BCT AGENDA  
January 21,2003  
1300-1600

**SUBJECT:** SEAD-16/17 Proposed Plan – Cleanup Goals (CUGs) for PAHs and metals and Cost/Volume Estimates

**Seneca Army Depot  
Ash Landfill  
Proposed Remedial Action Plan**

FIGURE 2-11  
 CASE 3 REMEDIAL ACTION OBJECTIVE  
 SUBSURFACE SOIL

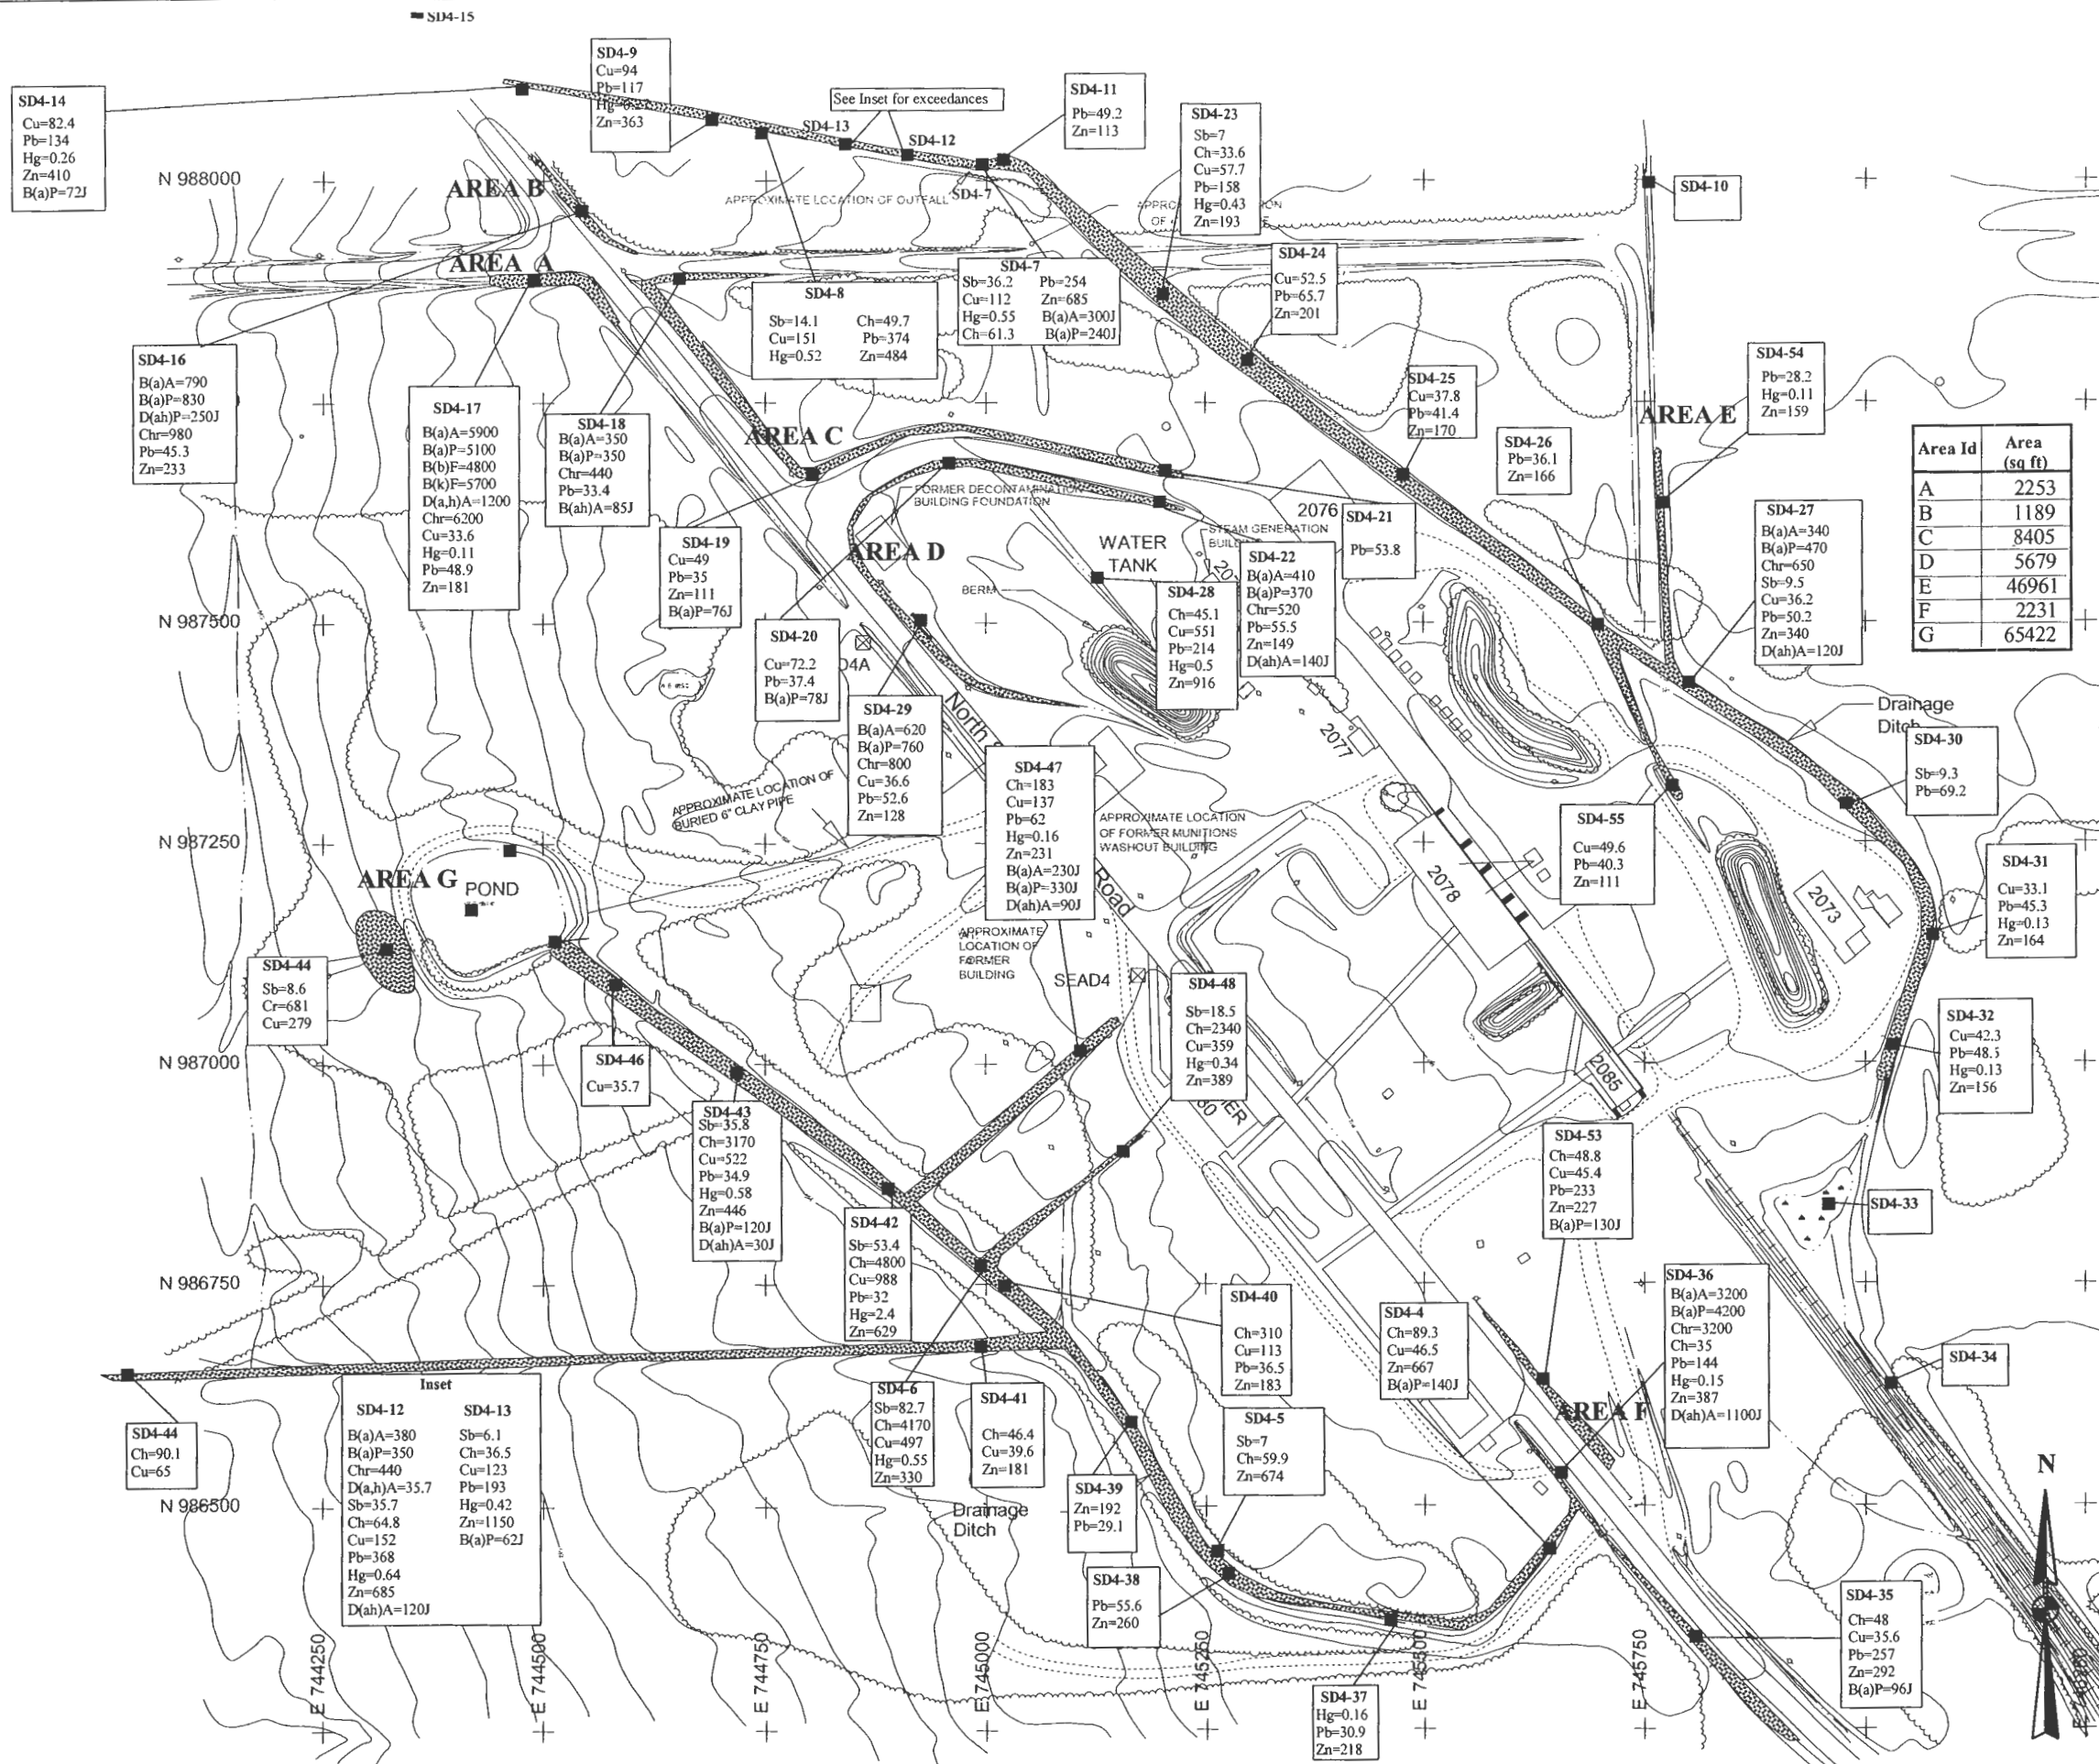
**Comment 12:** Figures 2-10 through 2-12: The tables in the legend of each figure are difficult to read. Please make them legible.
